Access Compliance Report

Public Rights-of-Way

Intersection ID: 2848	Main Street: DOWNFIELD_WOOD_DR	Cross Street: TUPELO_LN	Location: NE
ADA ID: 7D63B91B77C7	Ramp Type: Perp	Initial Pass/Fail: Fail	Overall Compliance: No
Severity Score: 13.75			
Codes/Mitigation Info/Possible Solution		Field Measurements/Component Compliance

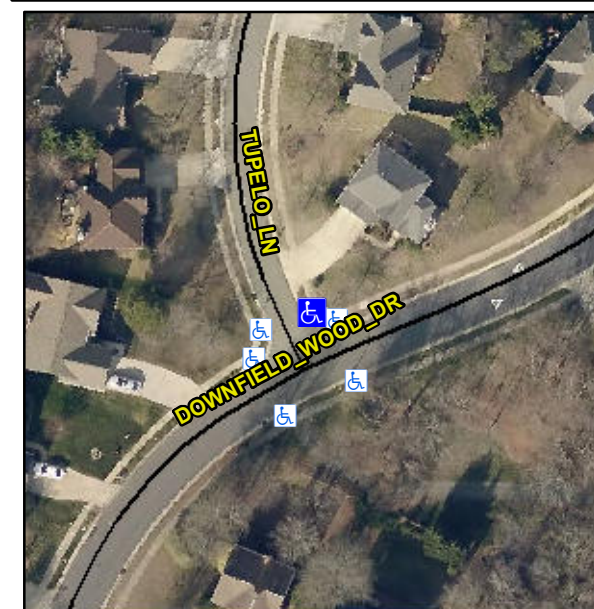
R304.2.2, R304.5.3

Compliance	Description	Data	Compliance	Description	Data
N/A	Ramp Length (in)	47.0	No	Ramp Slope (%)	9.5
Yes	Ramp Width (in)	51.0	No	Ramp XSlope (%)	3.6
N/A	Flare Type LT	N/A	N/A	Flare Type RT	N/A
N/A	Flare Slope LT (%)	N/A	N/A	Flare Slope RT (%)	N/A
N/A	Flare Traversable LT?	N/A	N/A	Flare Traversable RT?	N/A
N/A	Landing Length (in)	N/A	N/A	DWS Provided?	N/A
N/A	Landing Width (in)	N/A	N/A	DWS Contrast?	N/A
N/A	Landing Slope (%)	N/A	N/A	DWS Length (in)	N/A
N/A	Landing X Slope (%)	N/A	N/A	DWS Full Width?	N/A
N/A	Landing Curb? (Y/N)	N/A	N/A	DWS Offset (in)	N/A
N/A	Shared Landing?	N/A			
N/A	Gutter Ponding?	N/A	N/A	Gutter Slope (%)	N/A
N/A	Gutter Lip Ht (in)	1.0	N/A	Gutter X Slope (%)	N/A
N/A	Painted X Walk1?	No	N/A	Painted X Walk2?	N/A
	X Walk 1 Direction	To W		X Walk 2 Direction	N/A
N/A	X Walk 1 Width (in)	N/A	N/A	X Walk 2 Width (in)	N/A
	X Walk 1 Slope (%)	2.3		X Walk 2 Slope (%)	N/A
	X Walk 1 X Slope (%)	4.7		X Walk 2 X Slope (%)	N/A

Remove & Replace Entire Ramp.
